### **SAN ONOFRE NUCLEAR GENERATING STATION**

#### **IMPROVED TECHNICAL SPECIFICATIONS CONVERSION**

##### **ITS SECTION 3.0 LCO AND SR APPLICABILITY**

**Current Technical Specification (CTS) Markup  
and Discussion of Changes (DOCs)**

← INSERT Figure B 3.0-1 from Page B 3.0-10

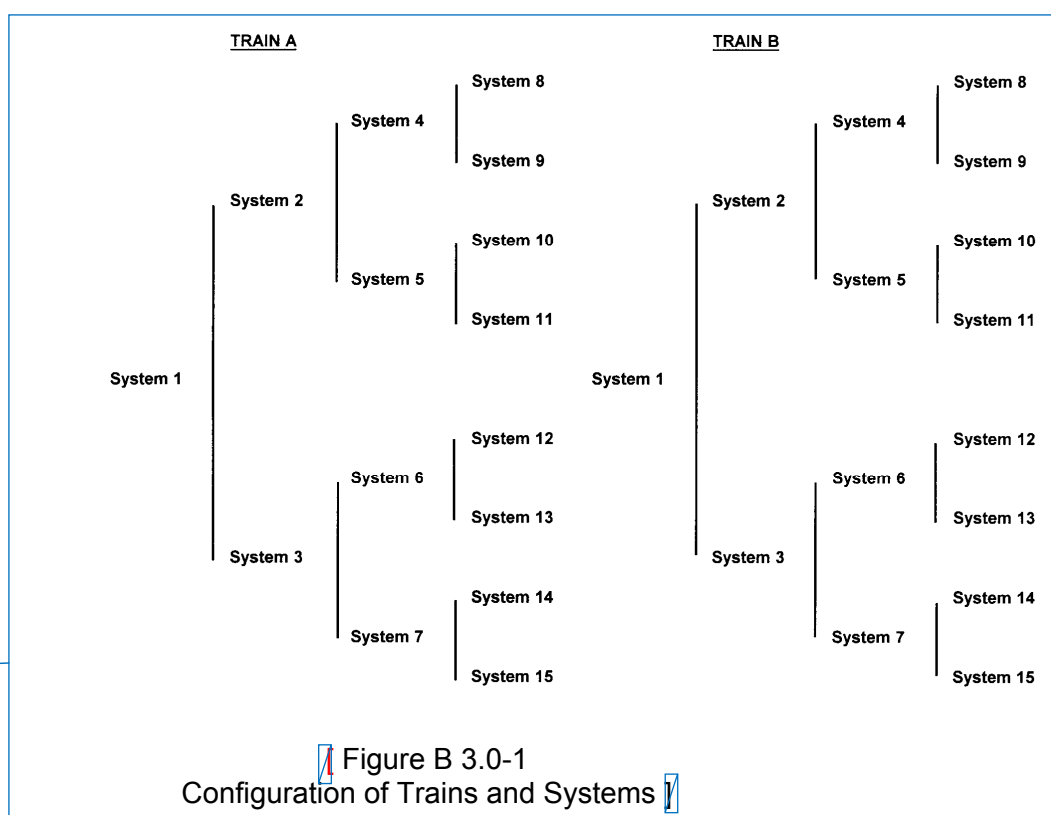
4. ISTS Figure 3.0-1 is being moved to the end of the Section, consistent with the format of the ISTS (Figures appear at the end of a Specification). Also, due to this movement, the Examples have been clarified to refer to the Figure.

- 1) Example B 3.0.6-1 is changed from "If System 2 of Train A is inoperable and System 5 of Train B is inoperable, a loss of safety function exists in supported System 5" to "If System 2 of Train A is inoperable and System 5 of Train B is inoperable, a loss of safety function exists in Systems 5, 10, and 11." Examining Figure B 3.0-1, it is clear that if there is a loss of safety function in System 5, there is also a loss of safety function in the systems supported by System 5, i.e., Systems 10 and 11. This relationship is explicitly listed in Example B 3.0.6-3 and to not do so here is inconsistent and confusing as it leads the reader to believe that Systems 10 and 11 do not have a loss of safety function. Furthermore, System 5 of Train B is not a supported System of System 2 of Train A, since they are in different trains. Thus, the word "supported" has been deleted.

Southern California Edison (SCE) needs to make these changes since the current wording in the ISTS 3.0.6 Bases are not correct. Furthermore, these changes are consistent with industry approved TSTF-494T.
